Product Change Notification

113350 - 01

Change Notification #: 113350 - 01
Change Title: Intel® Server System R2224GZ4GC4
PCN 113350-01, Product Design
Update the System Rear Panel, Resistors and Capacitor
Reason for Revision: Update BIOS/ME/BMC/FRUSDR
Date of Publication: November 14, 2014

Figure One

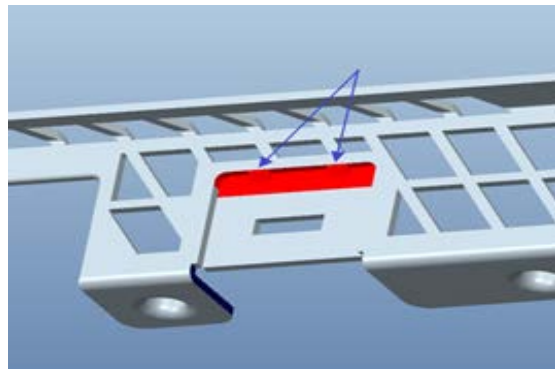
1. Update the one big center joint to two smaller joints so that the joints will not conflict with the LAN cable connector latch. See Figure One.

Figure Two

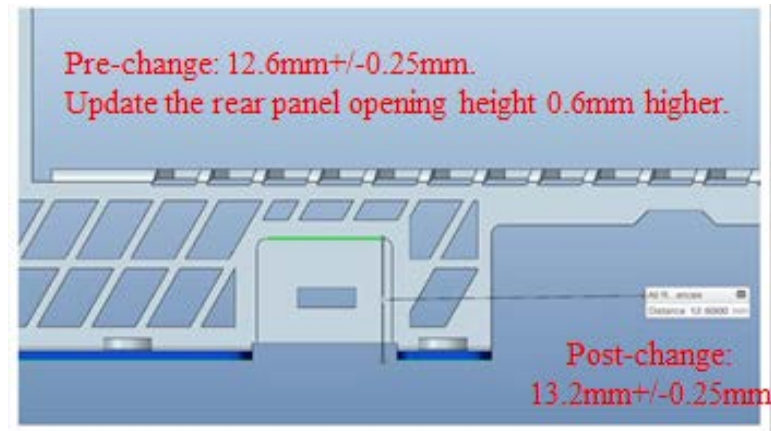
- Update the rear panel opening height 0.6mm higher to improve the flexibility for the cable latch. The previous height was 12.6mm \pm 0.25mm. The updated height is 13.2mm \pm 0.25mm. See Figure Two.

Figure Three

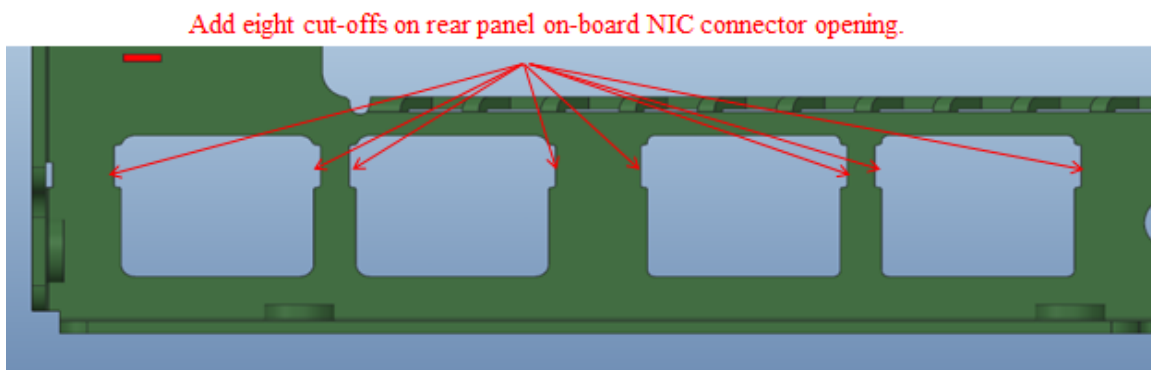
- Add eight cut-offs around the on-board NIC (Network Interface Controller) openings to improve the LED visibility. See Figure Three.

Figure Four. Component Locations for the 2U Riser Spare A2UL8RISER

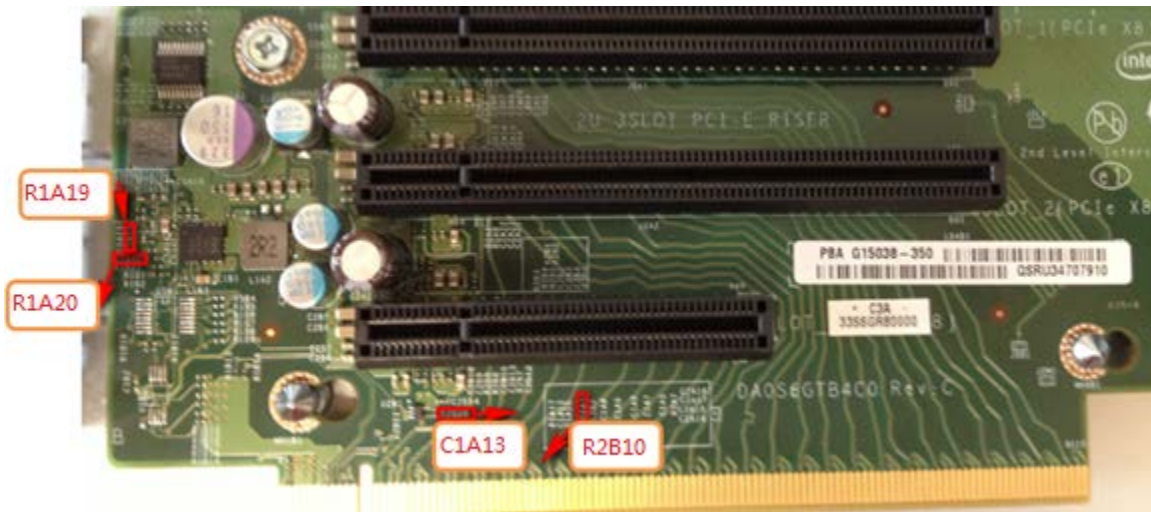
- Update the following resistors and capacitor (see Table One and Figure Four) on the 2U PCIe Riser Spare A2UL8RISER to make an improvement to support a higher 3.3 Voltage Regulator startup over current. Before this change, the Voltage Regulator on the riser card may not be able to turn on when the total current drawn is more than 5A current. After this change, the Voltage Regulator on the riser card can support more than 10A current.

Component	Location	Pre-change	Post-change
Resistor	R2B10	10.00 kOhm	3.65 kOhm
Resistor	R1A20	0 Ohm	30 Ohm
Resistor	R1A19	40.20 kOhm	20.00 kOhm
Capacitor	C1A13	10.00 pF	120.00 pF
